BEFORE THE ILLINOIS POLLUTION CONTROL BOARD

IN THE MATTER OF:)
) R 2020-019
STANDARDS FOR THE DISPOSAL OF)
COAL COMBUSTION RESIDUALS IN) (Rulemaking – Water)
SURFACE IMPOUNDMENTS:)
PROPOSED NEW 35 ILL. ADM.)
CODE 845)

PRE-FILED TESTIMONY OF DAVID E. NIELSON, P.E.

COMMENTS ON SECTION 845.420
LEACHATE COLLECTION AND REMOVAL SYSTEM

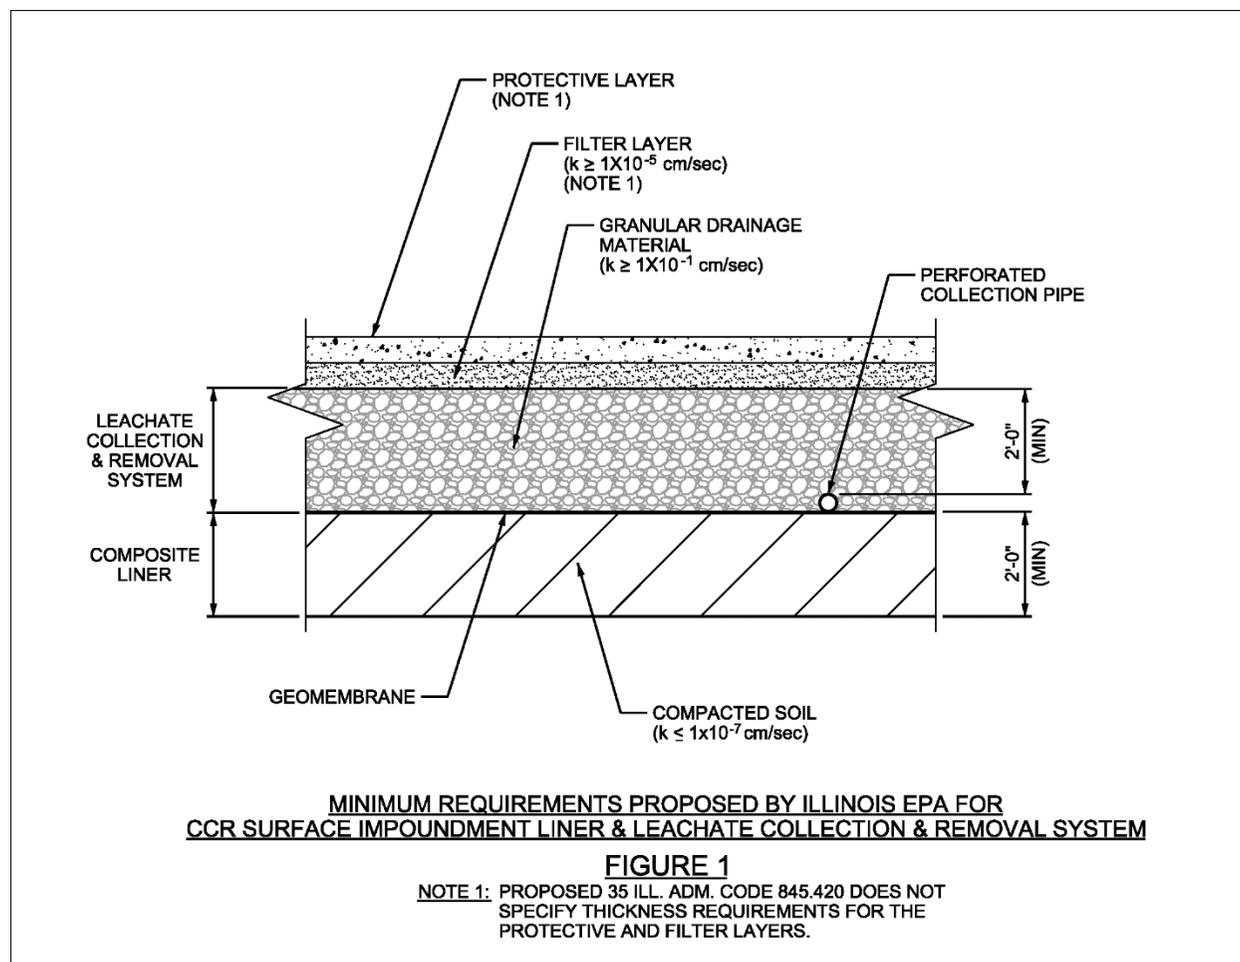
These requirements are graphically depicted in Figure 1. When a new or retrofitted CCR surface impoundment is operating, the CCR transport water (leachate) will be directly above the protective layer, which would likely be gravel or crushed limestone.

To better understand the implications of collection and removal of leachate from a pond floor, consider the following hypothetical scenario. The flow rate through the filter layer, which is the most restrictive layer above the leachate collection system, as required by the Proposed Illinois CCR Rule, for a hypothetical 20-acre CCR surface impoundment is calculated using Darcy's Law for flow through porous media. The flow per unit area (Q/A) is:

$$Q/A = 3.28 \times 10^{-7} \text{ ft/sec} \times ((20/.5) + 1) = 1.3 \times 10^{-5} \text{ ft/sec} = 0.048 \text{ ft/hr}$$

$$Q = 20 \text{ ac} \times 43,560 \text{ ft}^2/\text{ac} \times 0.048 \text{ ft/hr} = 42,000 \text{ ft}^3/\text{hr} = 5,300 \text{ gpm} = 7.5 \text{ million gal/day}$$

Since the hydraulic conductivity used in this example was the lowest permeability allowed by the Proposed Illinois CCR Rule, and since the filter layer thickness was assumed to be six inches, the calculated flow could be significantly higher with more permeable or thinner filter materials. It is noted that in my experience with CCR sluice systems, the flow rate into the pond is typically on the order of 3,000 to 5,000 gpm. Thus, this hypothetical CCR surface impoundment would not be able to contain significant free water since the flow rate into the leachate collection and removal system would be effectively equal to the flow rate of CCR into the impoundment. Consequently, this hypothetical pond would generally be dry, which would result in a higher likelihood of fugitive dust risks to the environment.

I encourage the Pollution Control Board to implement pond design requirements that are identical to those in the Federal CCR Rule. The Federal CCR Rule is the result of many thousands of hours of thoughtful work by scientists, engineers, and regulators of the US EPA and other interested parties, which in my opinion, is an appropriate regulation for the protection of human health and the environment. Specifically, I encourage the Illinois Pollution Control Board to remove Section 845.420 of the Proposed Illinois CCR Rule along with any references to leachate collection and removal systems.

Alternatively, if the Board concludes that more proactive measures are required for protecting groundwater than those prescribed by the Federal CCR Rule, I suggest that the Board include language in 845.420 that would allow an entity to install an alternative leachate collection system that is at least as protective as the system required in 845.420(a).

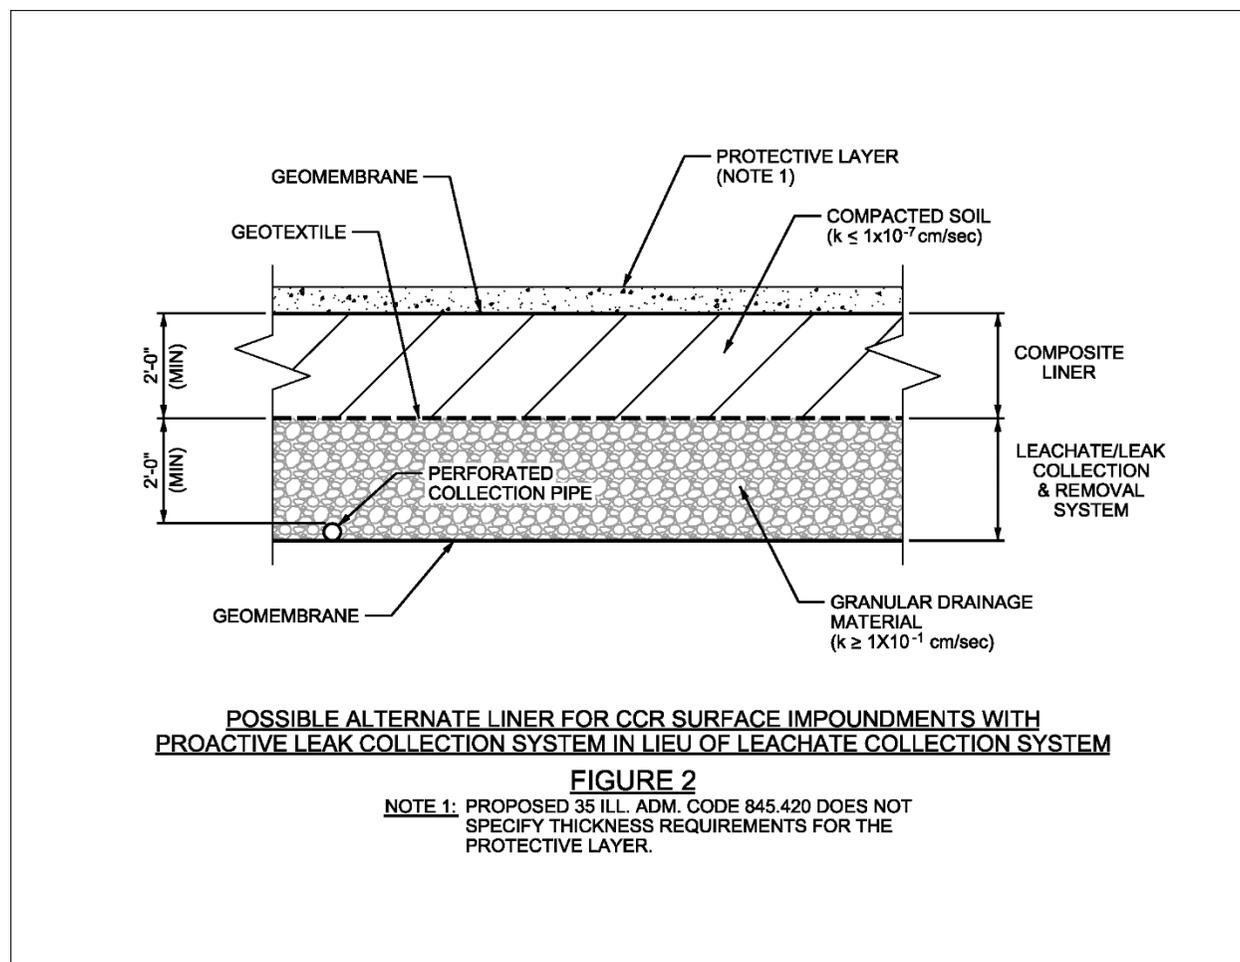
It is recognized that the existing geomembrane liner cannot be considered as a component of a new compliant composite liner system. Although not incorporated into the composite liner system, it is my opinion that allowing existing, effective liners to stay in place could add an additional level of protection of the environment. It is certainly a better alternative than requiring removal of a decontaminated liner and transporting it to a solid waste landfill, which in my opinion is not in compliance the reuse and energy conservation concepts that are fundamental to environmental stewardship.

I recommend that the language of section 845.770 be modified to allow existing geomembrane liners to be decontaminated, similar to the Federal CCR Rule requirements. The decontamination could include cleaning with high-pressure water washes, visual inspections for any damage, repair if damage was a result of the removal of CCR, and reuse as a supplemental layer below a new composite liner as suggested in Figure 2.
